PLANNING DIVISION STAFF REPORT

Project Address: 8110-8134 Mid-Town Road, 1833-1859 Waldorf Boulevard, 8137 Mayo Drive, and 1902 Carns Drive (District 1 – Ald. Harrington-McKinney)

Application Type: Planned Development Zoning Map Amendment

Legistar File ID # [59635](#)

Image 1: Commercial Square-Footage Allocations of the 2007 Midtown Center GDP

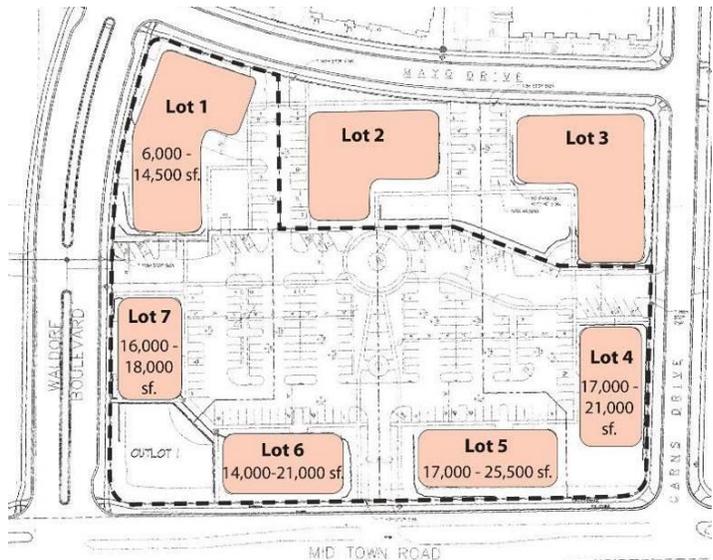
The 2007 Midtown Center GDP envisioned Lots 1, 4, and 7 (i.e. the lots fronting onto Waldorf Boulevard to the west and Carns Drive to the east) to be mixed-use (residential over commercial) and Lots 5 and 6 (fronting onto Mid Town Road) to be solely commercial. It recommended roughly 70,000-100,000 square-feet of commercial space across the five parcels. (See Image 1 to the right) Staff note that the 2000 Midtown Commons GDP classified the subject parcels as “Mixed-Use (Type V)” use (sub district). It also indicated that this stretch of Waldorf Boulevard was considered “Main Street Commercial” for which the GDP’s Zoning Text required commercial uses to occupy [at least some part of] the ground floor of buildings.

The applicant is proposing to not provide any commercial space in any of the three buildings, due to both the site constraints (due to the considerable amount of slope running north-to-south across the site), as well as the perceived lack of market viability of commercial uses at this location.

Image 4: (left) The seven buildings proposed in the 2007 Midtown Center GDP (five are located on the subject property, which is outlined); (right) the three proposed buildings

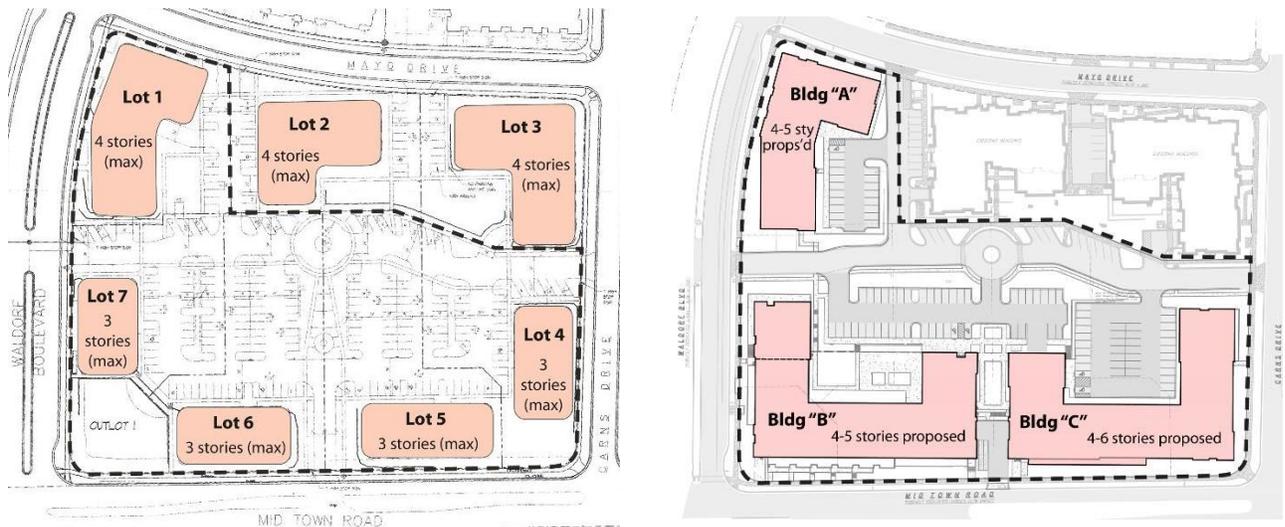
Whereas the Comprehensive Plan and High Point NDP both recommend buildings to four stories (with an exception in the case of the NDP, which allows larger buildings *“in very select locations”*), the applicant is proposing three buildings that range from four to six stories. (See Image 4, below)

While staff recognize that there are challenges to properly siting buildings on a site with roughly 39 feet of grade change, Staff believe that grade was one of the considerations as why the 2007 GDP proposed four smaller-footprint buildings on the southern half of the site, as smaller-footprint buildings result in less exposure of lower levels. The larger buildings, as proposed, result in some sizable expanses of blank façade. This is most notable along Waldorf Boulevard. (See Image 5 on the following page for an example.) Staff are particularly concerned with the resulting amount of blank façade located at the pedestrian level.
